STAFF RECOMMENDATION

207 South Twelfth Street

March 15, 2017

Application: New construction—infill

VICINITY SITE PLAN DIAGRAM

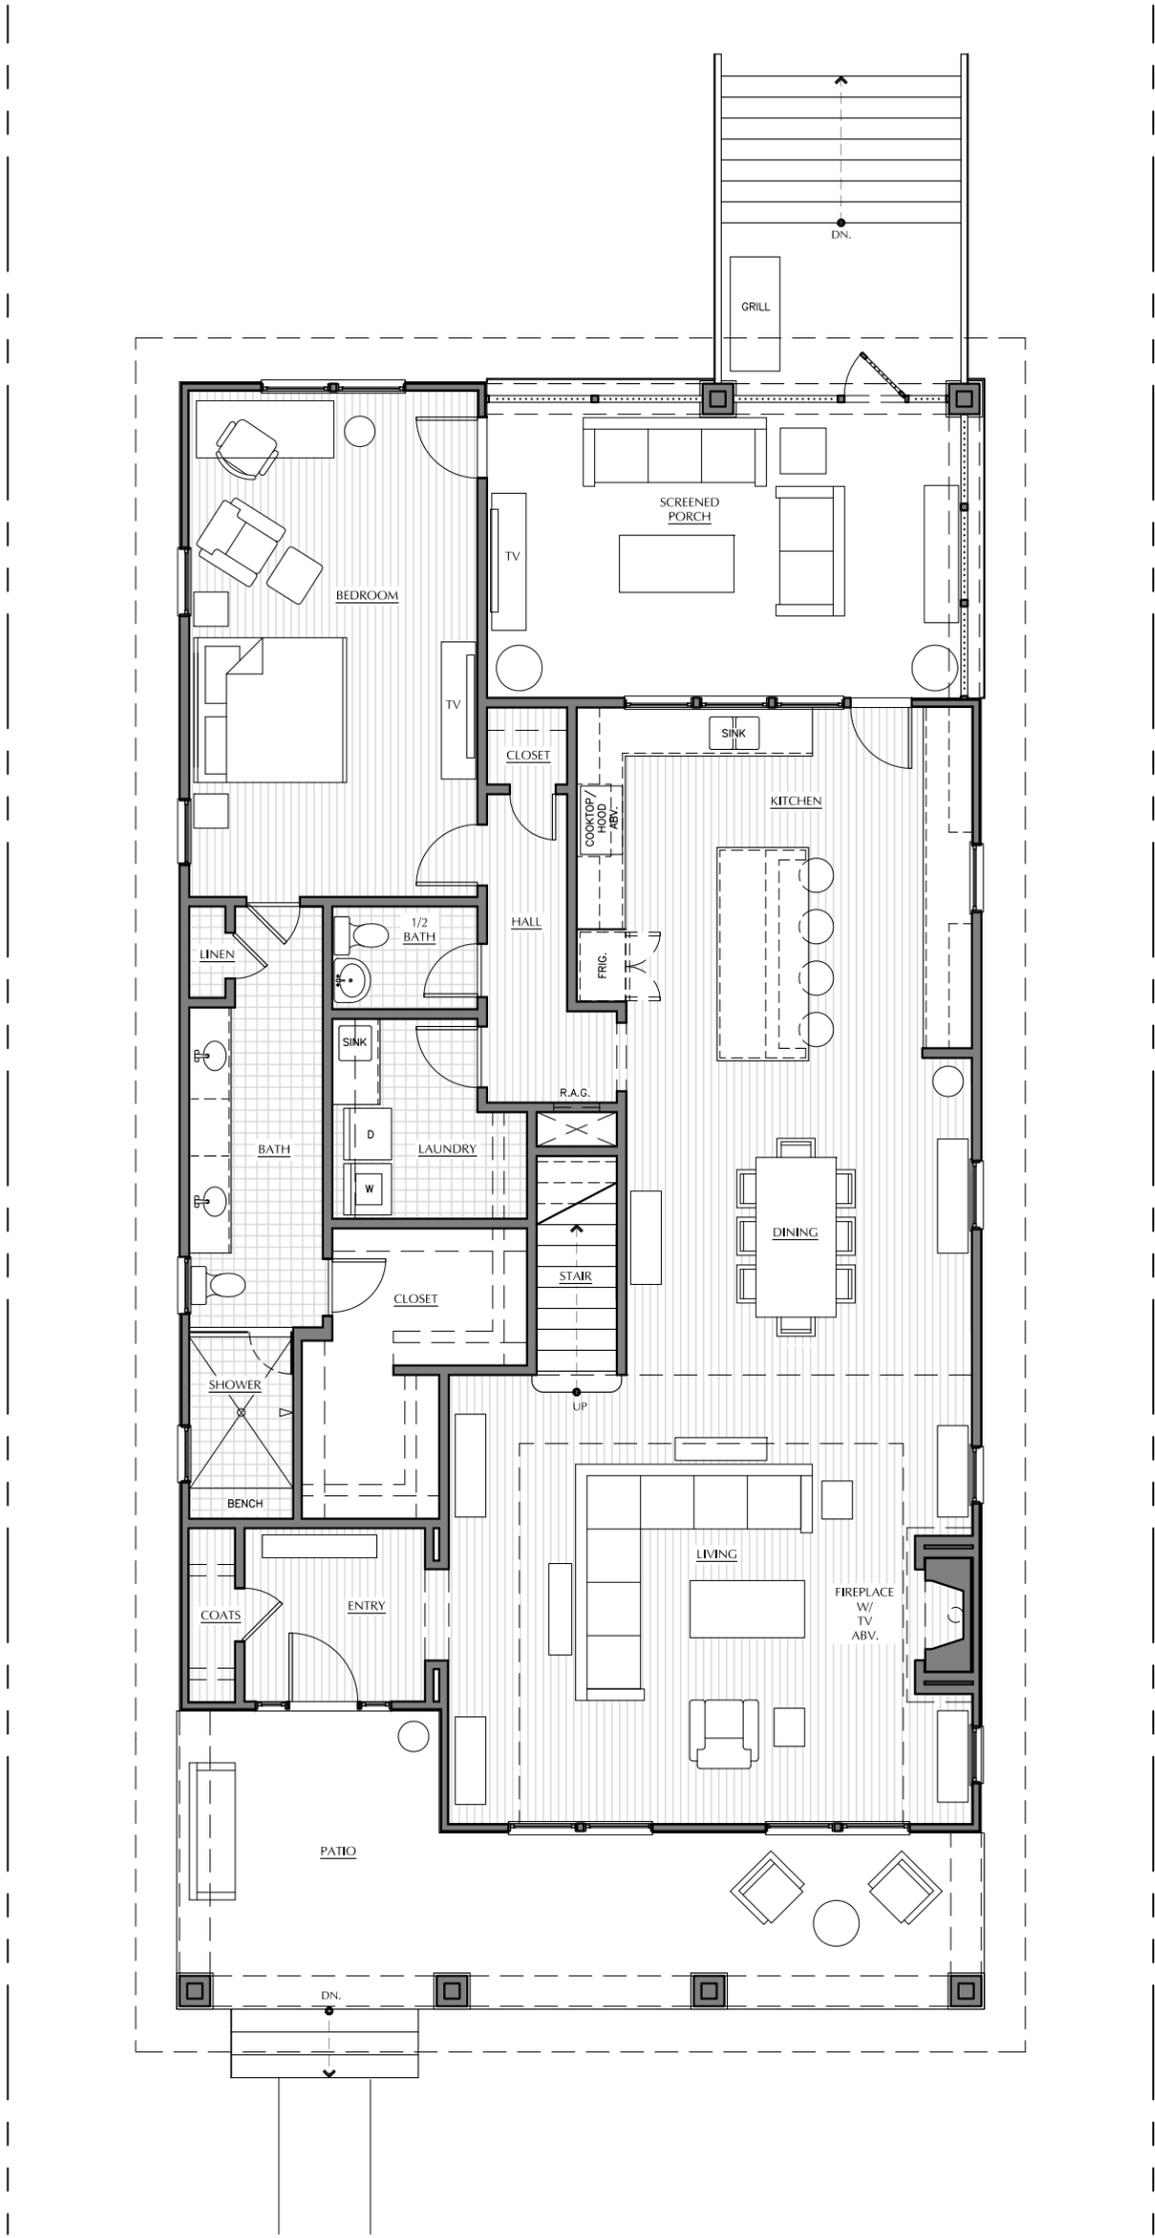
Appurtenances & Utilities: The infill includes a walkway leading from the street to the front porch. The driveway and/or parking pad location is not noted on the plans, and staff asks that this be shown on the site plan prior to issuance of the preservation permit. The location of the HVAC and other utilities was not noted on the plans. Staff asks that the HVAC be located on the rear façade, or on a side façade beyond the midpoint of the house, to ensure that the project meets section section II.B.1. i.

SOUTH ELEVATION (RIGHT SIDE)

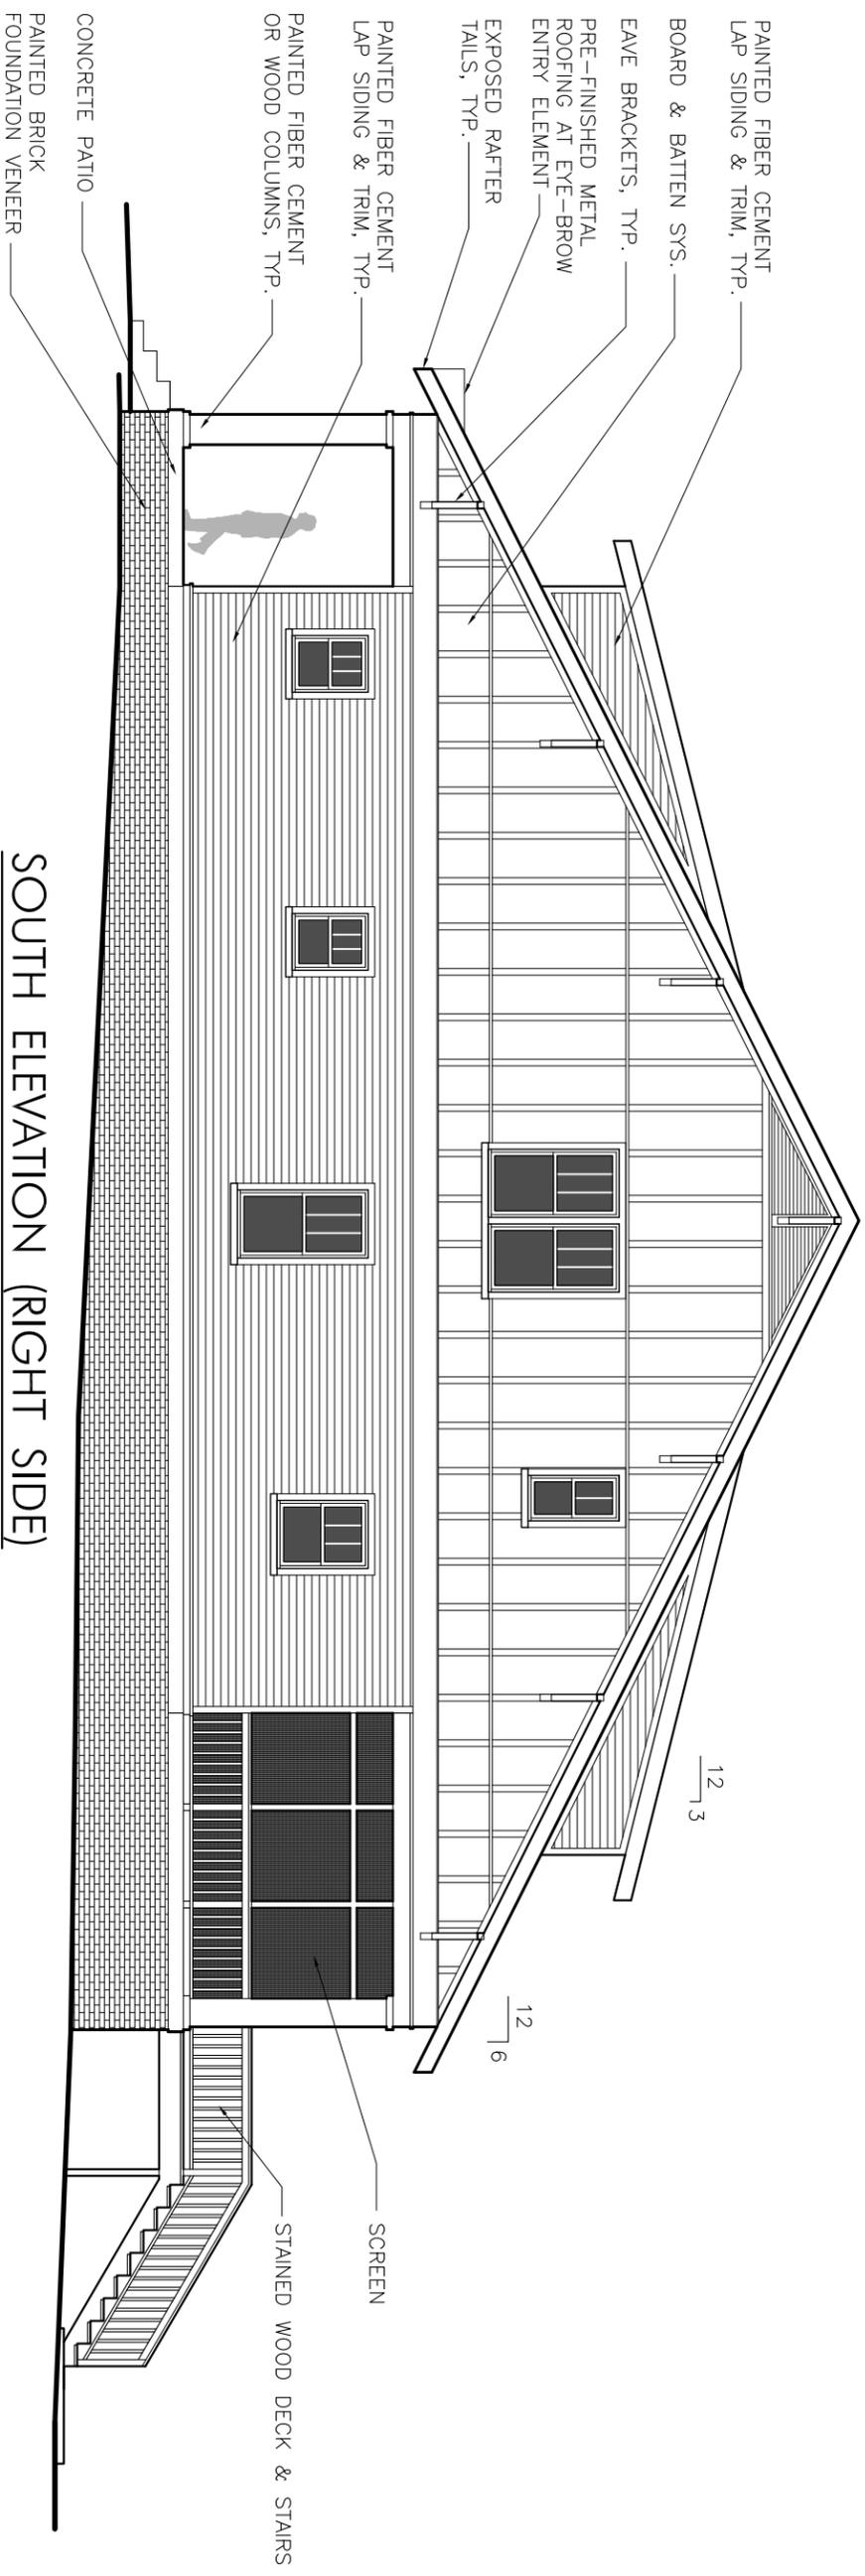
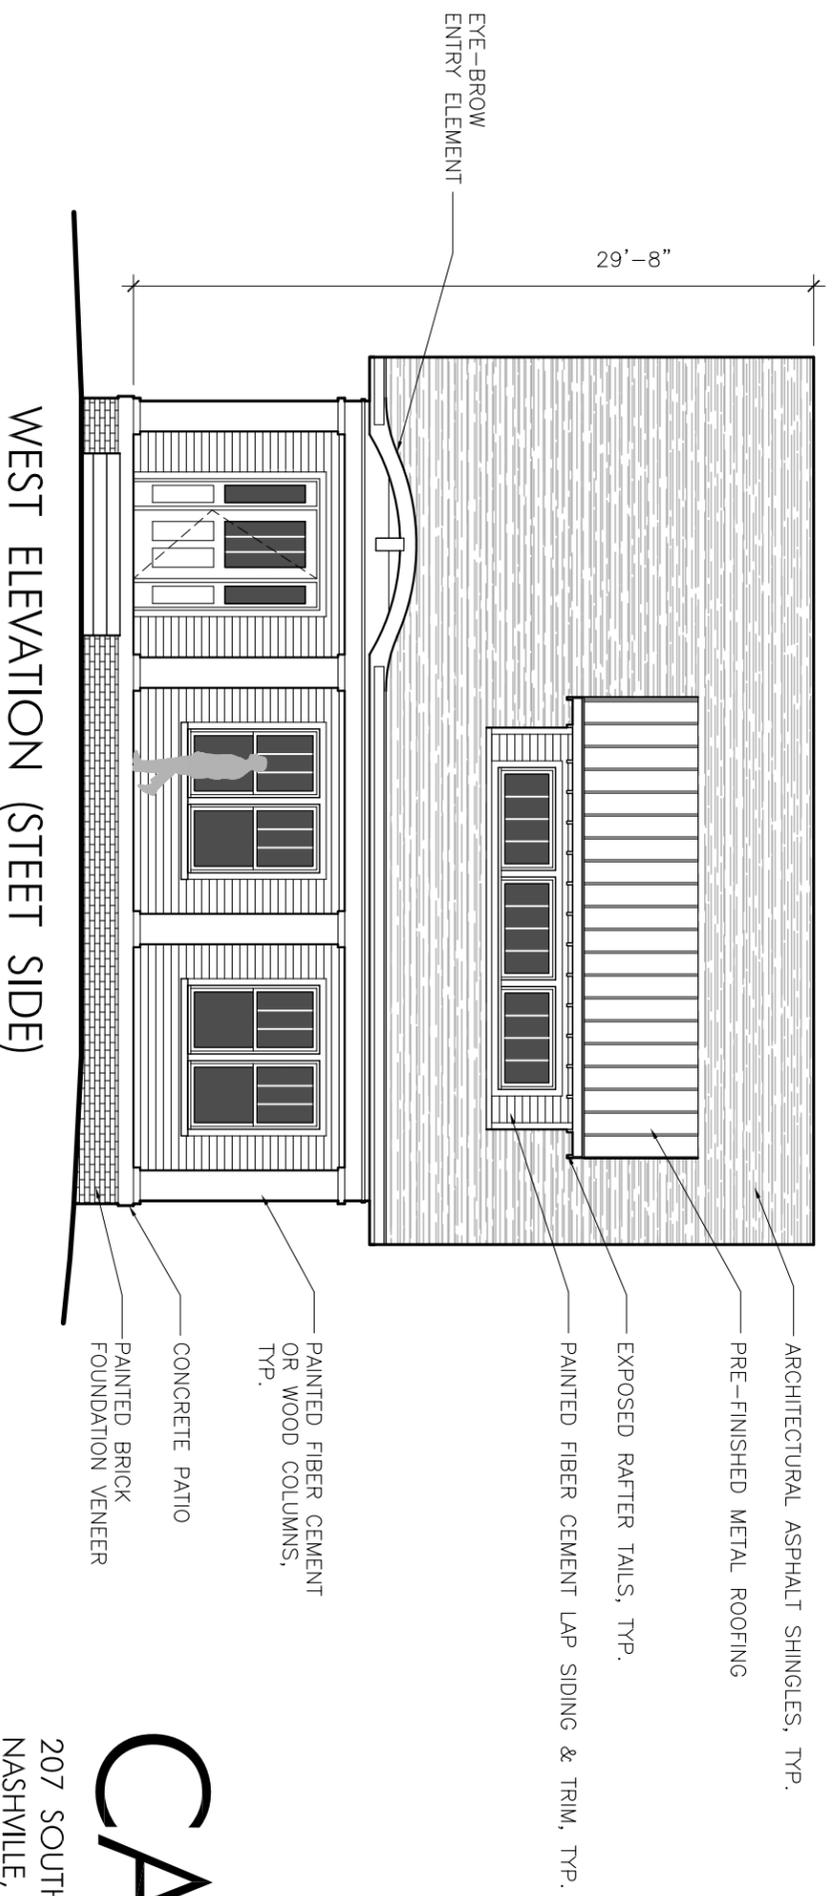
Height & Scale: The proposed infill is one and one-half (1.5) stories at the front with an overall height of thirty-one feet, eight inches (31'-8") from grade, including a foundation height of approximately two feet (2'). The overall height of the infill is modest compared to the historic context, which includes two story homes, including the two adjacent homes that range from thirty-six to thirty-eight feet (36'-38') in height. The infill will have an eave height of approximately nine feet, eight inches (9'-8"), which is appropriate for a one and one-half (1.5) story home.

The infill will have a painted brick foundation, fiber cement lap siding with board and batten accent, and an asphalt shingle roof. The reveal and finish for the siding is not noted, so staff recommends a condition that the siding have a smooth finish and a maximum reveal of five inches (5”). With the condition that staff review the roof color, masonry, board and batten, windows, doors, front porch steps, driveway/parking pad, and walkway material prior to purchase and installation, staff finds that the project meets section II.B.1.d.

Roof form: The roof will be side-gabled with a 6:12 pitch and includes shed dormers on both the front and rear façades with a 3:12 pitch. Staff finds that the roof form and pitches are compatible with the historic context and meet section II.B.1.e.
